Wisconsin Department of Transportation

NOTICE TO ALL CONTRACTORS:

| <p>Proposal #51: 1060-33-94, WISC 2019 219

This is Addendum No. 01, which provides for the following:

Addendum No. 01
 ID 1060-33-94
 Added Sheet 52A
 May 2, 2019

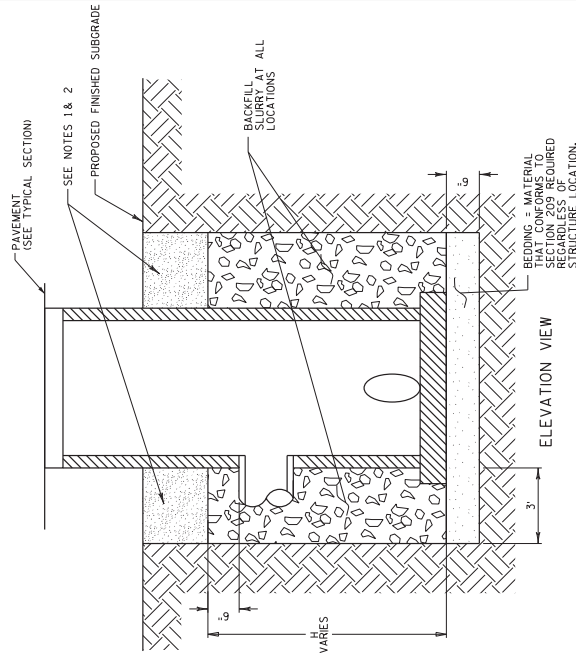
Added Plan Sheets – Project ID 1060-33-94	
Plan Sheet	Plan Sheet Title (brief description of why sheet was added)
52A	Backfill Slurry detail for storm sewer (omitted from plan set)

Added: 1060-33-94: 52A

BACKFILL SLURRY DETAIL - STORM SEWER TRENCH

BACKFILL SLURRY DETAIL - STORM SEWER STRUCTURES

Addendum No. 01
ID 1693-37-74
Added Sheet 17A
May 2, 2019

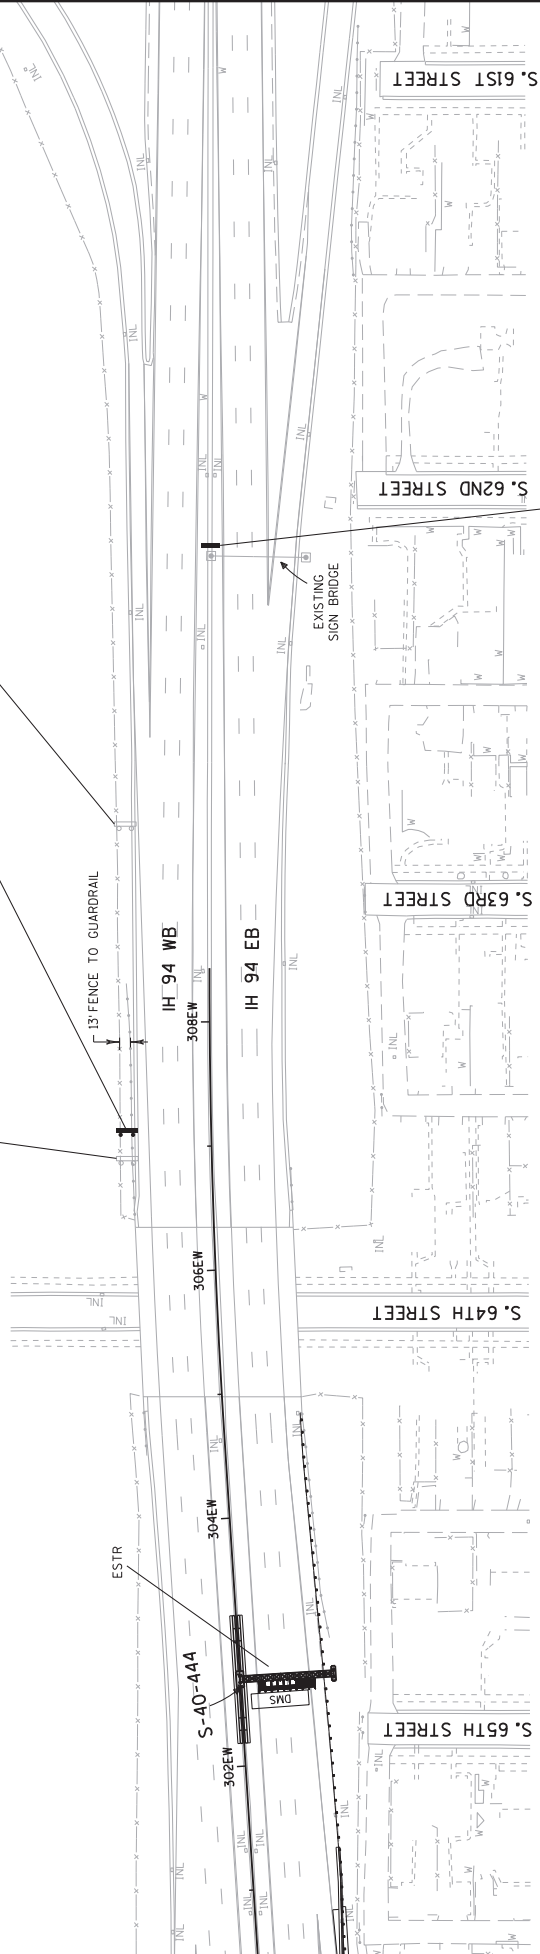
Added Plan Sheets – Project ID 1693-37-74	
Plan Sheet	Plan Sheet Title (brief description of why sheet was added)
17A-F	Permanent Signing (new signs added to contract)
32A	Permanent Signing Quantities (second sheet needed due to additional signs)
73A-B	Permanent Signing Details (new signs added to contract)

Addendum No. 01
ID 1693-37-74
Revised Sheet 73
May 2, 2019

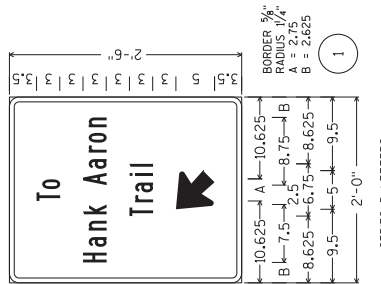
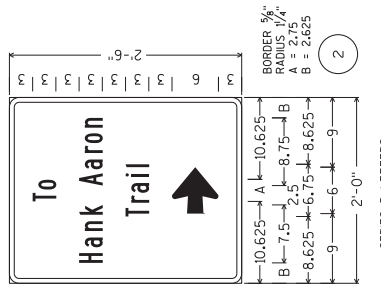
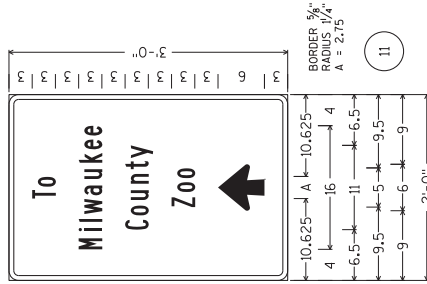
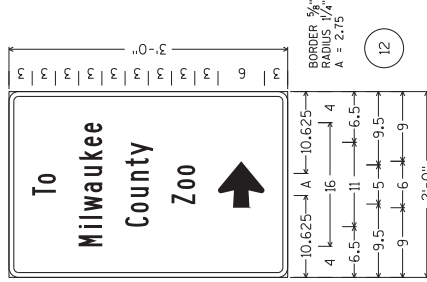
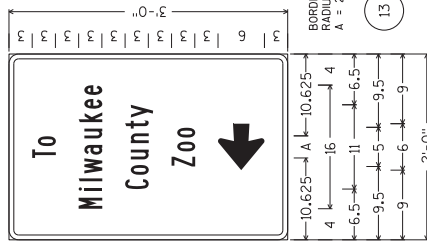
Revised Plan Sheets – Project ID 1693-37-74	
Plan Sheet	Plan Sheet Title (brief description of changes to sheet)
2	General Notes and Utility Contacts (updated utility contacts)
32	Permanent Signing Quantities (additional signs listed)
73	Signing Detail – Type II Signs (sign color clarification added for first two signs)

Addendum # 1 - Signs
1 and # 2 to be
brown with white
letters
